**KELLER SPRINGS LOFTS**  
LOFT APARTMENTS IN ADDISON, TEXAS

ELEVATIONS

RFI #: 39  
Date: 1/28/2012  
Job: EB-02 Keller Springs Lofts  
Phone: 877-777-5115

CC: David Gallagher (Embrey Builders LLC)  
Subject: Elevation conflict A1 part 5

**4.4**

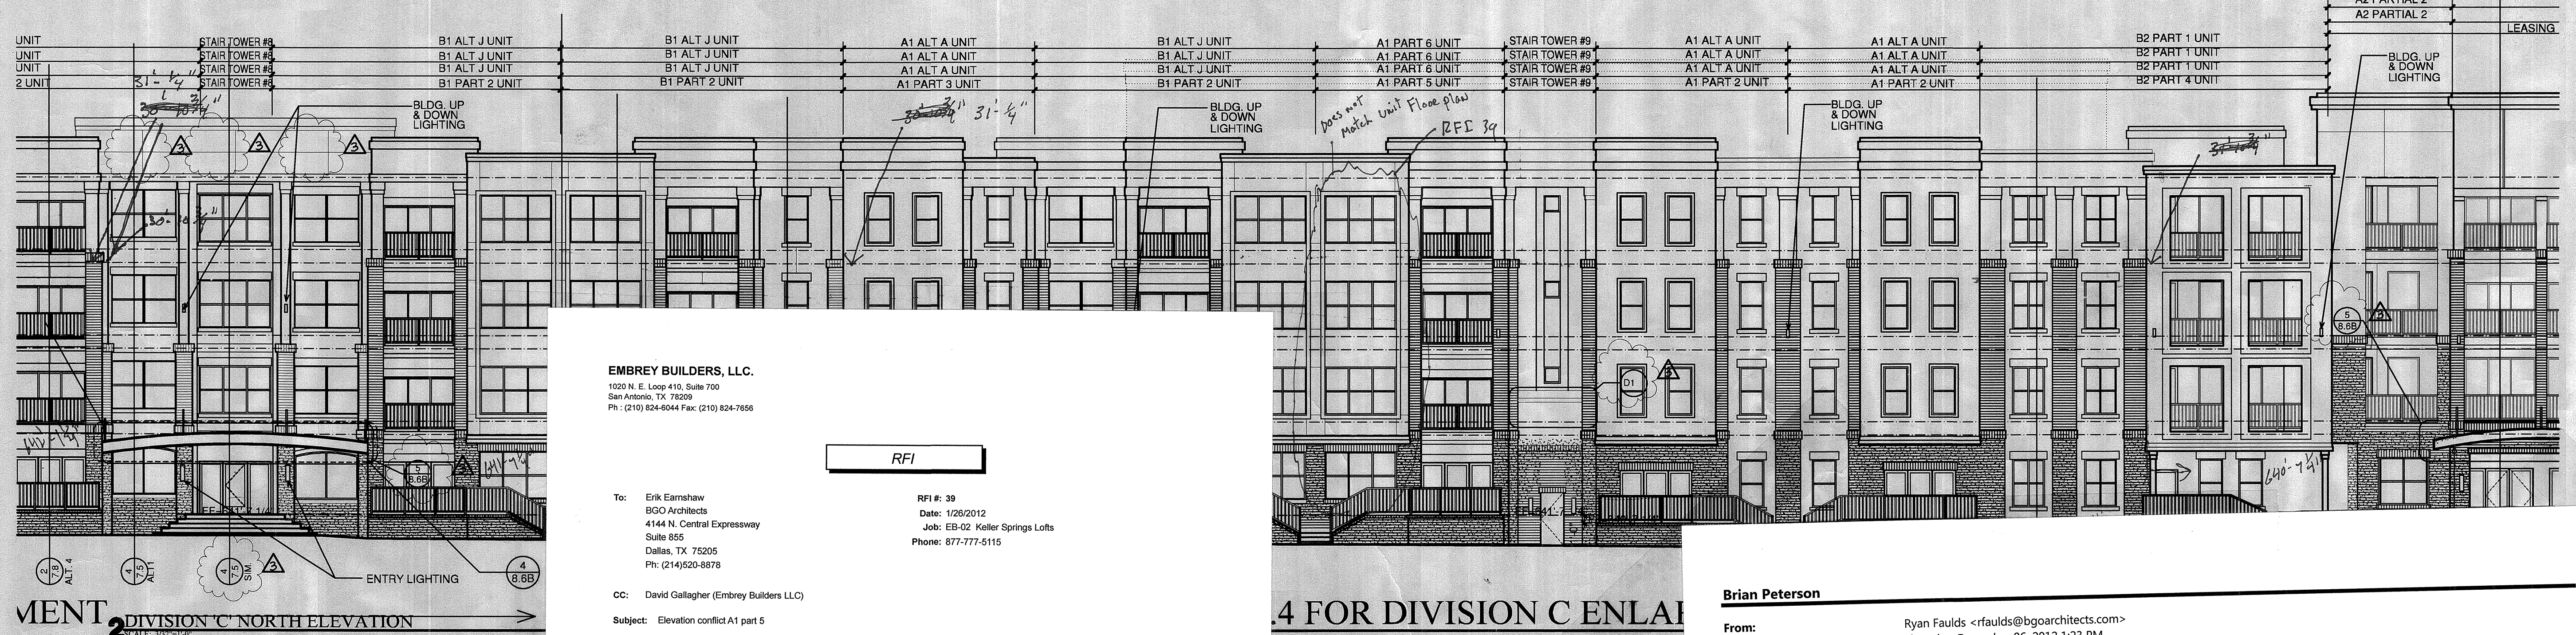
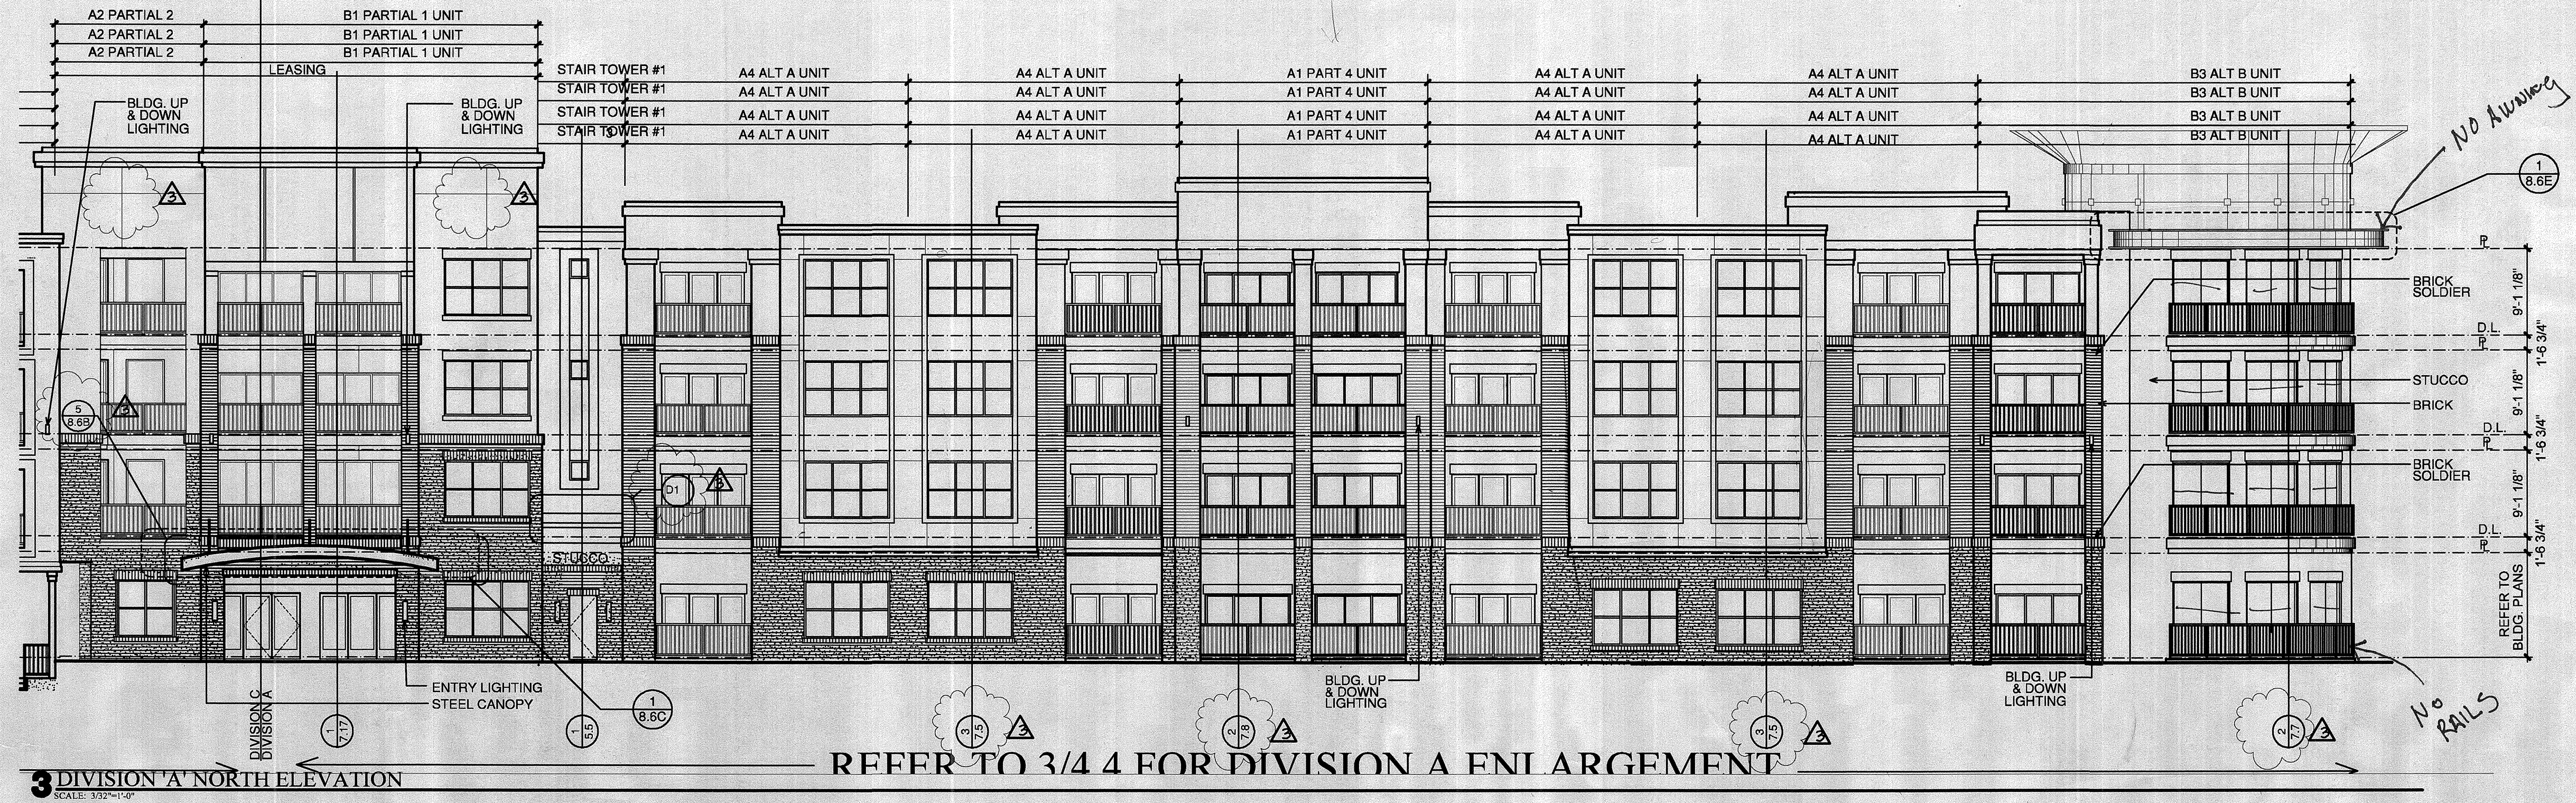
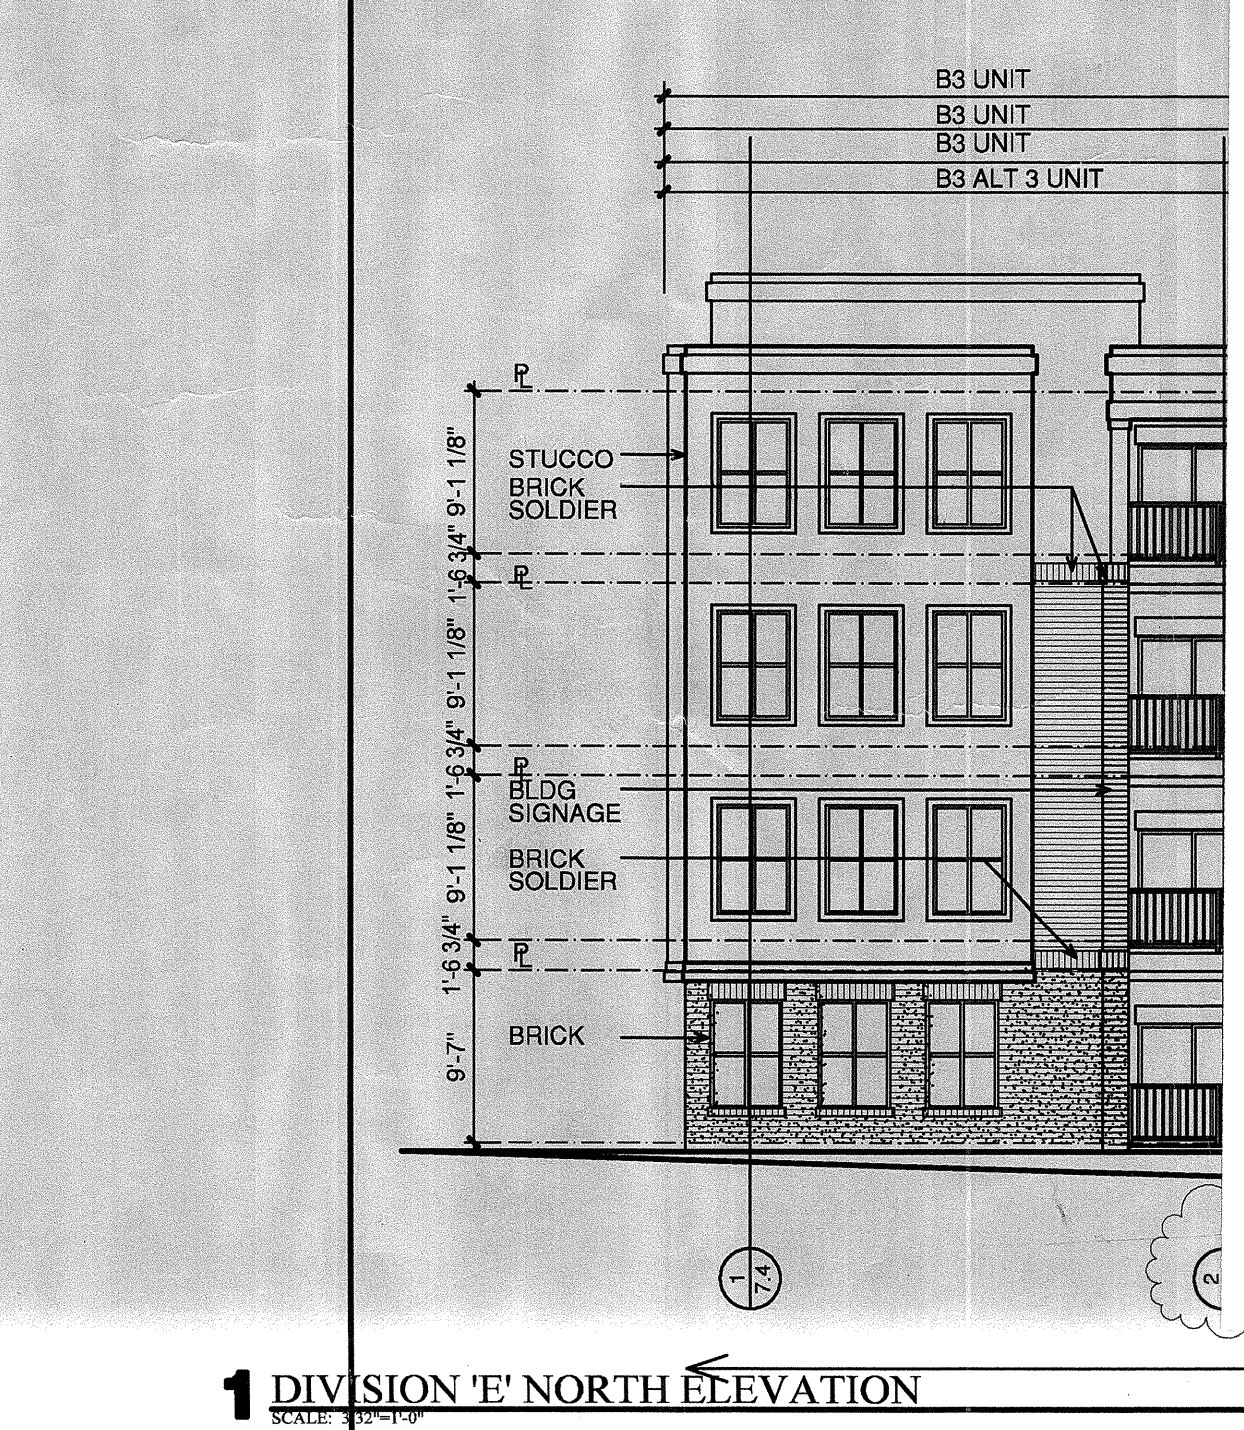
**Request:**  
Erik there is a conflict on A1 part 5 (1st floor) and A2 part 6 (2-4 floors). 2/4.4 shows these units to the left of stair tower #9 elevation clearly shows these windows matching the B3 mark windows of the adjoining B1 units. However, 12/2.2 and 13/2.2 calls out mark 17 which is 3x6' 8" triple fixed french doors. Please see attachments.

**Response:**  
The elevation is drawn accurately per the design intent.  
The plans have been updated.  
see next page.
